Airstream Service Bulletin

Bulletin Number: 181

Product Line: Airstream Atlas

Subject: VB Air Ride Auto Ride Height Change

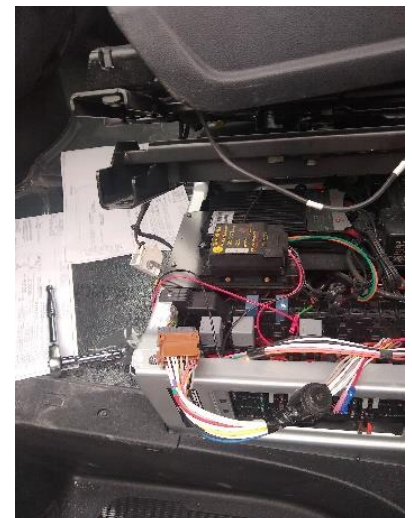
2) Disconnect the vehicle body ground connection by removing the cover, located beside the accelerator pedal. Next, reach into the lower center column and release the ground cable for the chassis bond. This will require pushing down on the red button and pulling out on the grounding cable.

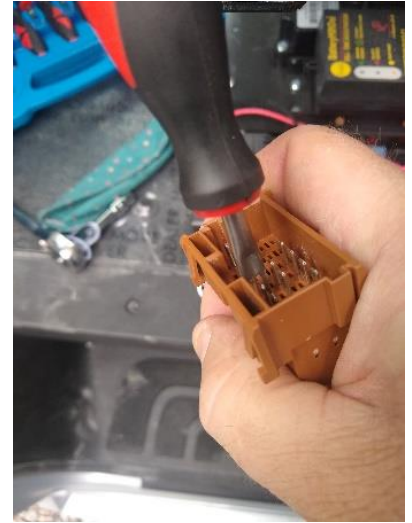
5) Reach into the seat base and pull out the 21-pin connector and separate the connection. (A Brown connector plugged into a gray connector)

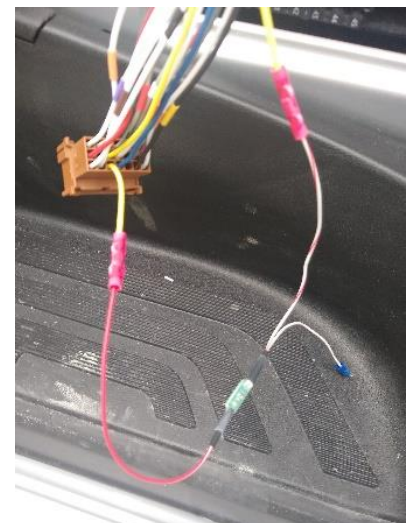
- 6) Working with the brown connector, locate pin 7 (Output 7) and remove it from the connector. Move this pin to the open pin 2 spot (Output 2) on the same connector.

- 7) Next, remove pin 14 (Output 14) and reinstall it in the now open Pin 7 (Output7) location. This is the same spot that you vacated in the previous step.
- 8) From the new pin 7 (Output7) above, trace down the wire about 3" and cut the Output 7 wire.
- 9) Remove the Channel Invert Board from the kit and install the pink butt splices onto the two striped wires. The solid white wire exiting the board will get the ring terminal attached to it.

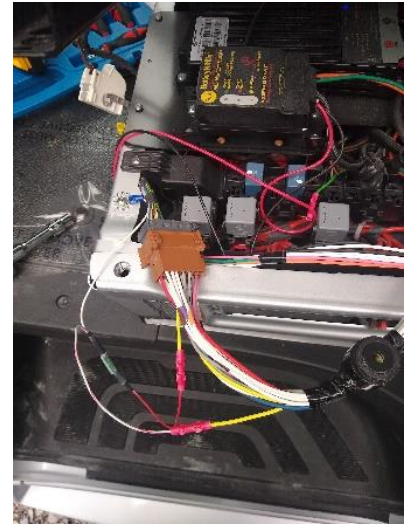
- 10) Connect the butt that exits as a single wire from the invert board (See Above) to the cut wire exiting the brown connector pin 7 (See wires in step 8 above). Next, connect the stripped butt spliced wire from the other end of invert board to the cut wire end that goes back into the harness.

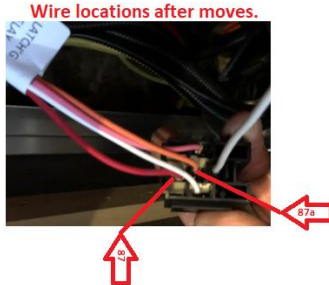
- 11) The invert board's solid white wire, with the ring terminal, is then attached to the top of the seat base using the self-tapping screw and star washer. Use a power drill to install the screw.

- 12) Now find pin 3 on the brown connector and cut the wire apart about 3" from the connector. Place a butt slice on the wire going into the harness. The wire coming out of the connector is butt sliced to the new 20ft extension wire. The extension wire needs to run into the corner cabinet where the Magnum converter rein sides. The floor board behind the driver's seat is removable and can pass the wire behind the seats. Use the drill to make a passage under the floor to the corner cabinet.

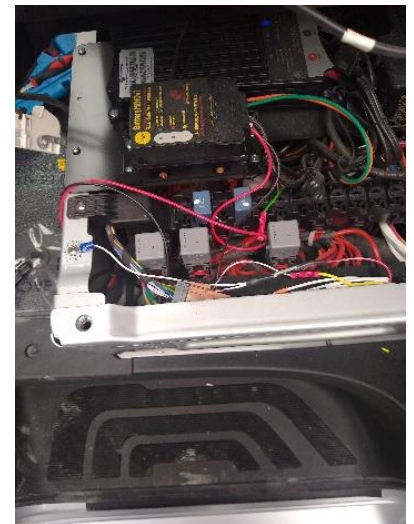
- 13) Once the wire is in the corner cabinet it will need to connect to the “Latching Relay” (LLR). This relay is located below the Magnum converter along the bottom edge of the board. There are multipole relays in a row with the tallest one being the “Latching Relay”. Remove it and its socket from the wall. With the relay removed from the socket release the terminal in the 87 position (old LST wire, ORG) and move it to the 87a position. See the face of the relay itself for the pin numbering. Once 87 has moved to 87a position insert the extension wire into the 87 position. Reattach the relay socket to the wall and install the relay. Return all compartments and covers back to their original state
